UNITED STATES DEPARTMENT OF COMMERCE United States Patent and Trademark Office Address: COMMISSIONER FOR PATENTS P.O. Box 1450 Alexandria, Virginia 22313-1450 www.uspto.gov

| APPLICATION NO.  | FILING DATE | FIRST NAMED INVENTOR                     | ATTORNEY DOCKET NO. | CONFIRMATION NO. |
|--|-------------|--|---------------------|------------------|
| 10/561,468   | 12/20/2005  | Robert Alexander Van Eibergen Santhagens | NL030751            | 8162             |

|   | Application No.  | Applicant(s)                               |  |  |  |
|---|--|--|--|--|--|
| Office Action Summary   | 10/561,468   | VAN EIBERGEN SANTHAGENS,<br>ROBERT ALEXAND |  |  |  |

## **DETAILED ACTION**

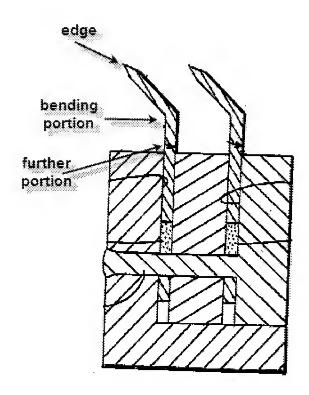
With respect to claim 1, Emmett discloses a razor head (it is old and well known in the art for a razor blades to be supported in a razor head) having one or more fixed bridge partitions (see figure 8) and at least one razor blade (302) attached to a corresponding fixed bridge partition of substantially equal length (see figure 8), each blade comprising an edge portion with a cutting edge (306), a bending portion (see figure 8, below) positioned between the edge and the further portions, where the edge portion is bent relative to the further portion (see figures 7 and 8) and the bending portion (see figure, below) is spaced from said cutting edge and the fixed bridge partition (see figure 8).

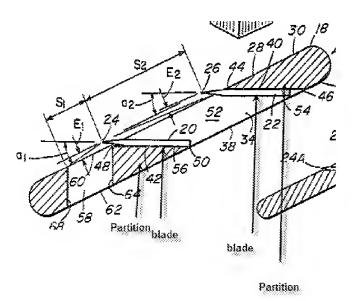
Ciaffone discloses a side of a top blade (Fig. 2, 20, 22) attached to a bridge partition (Fig. 2, 40, 42) of a razor head, and a bottom side (Fig. 2, 20, 22) of a further portion being remote from a corresponding bridge partition and spaced apart in its

entirety from any other structure (Fig. 2, see below, it has been interrupted by the Examiner notes, the side of the further portion is spaced apart in its entirety from any other structures). Therefore, it would have been obvious to one having ordinary skill in the art at the time of invention to provide Emmett with a bridge partition as taught by Caiffone. The bridge partition of Caiffone utilizes less material, which reduces cost and provides a passageway for debris (hair) during a cutting process (Col. 3, lines 4-11, Caiffone). It would have been obvious because a person of ordinary skill has good reason to pursue the known options within his or her technical grasp. If this leads to the anticipated success, it is likely the product not of innovation but of ordinary skill and common sense.
